MEMORANDUM

RE: ZP15-0129CA/CU; 1398 North Avenue

Request: Demolish existing building and construct new two story building with neighborhood commercial food store/market with takeout prepared food and an office on ground floor and two residential units on second floor.

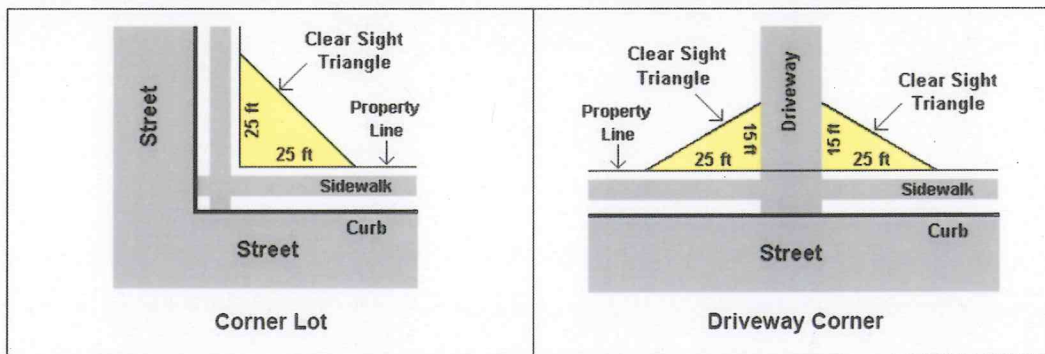
The parking is located at rear of the lot and thus not visible from the adjacent public rights of way. This parking area extends the entire width of the lot and provides no curb stops, landscaping or other barriers to prevent encroachment beyond the parking area.

There is no physical separation between moving and parked vehicles and pedestrians in a manner that that minimizes conflicts and provides pedestrians with a safe and unobstructed route to the building entrance. This needs to be redesigned, possibly with a rear entrance into the building directly from the parking area precluding the need to walk up the driveway.

No bicycle parking is indicated and a bike rack should be provided in the front of the building. **Adverse finding as submitted.**

9. **Prior to release of the zoning permit** the parking area at rear of the lot extends the entire width of the lot without any curb stops, landscaping or other barriers to prevent encroachment beyond the parking area. Therefore, barriers must be provided. The details are subject to review and approval by staff.
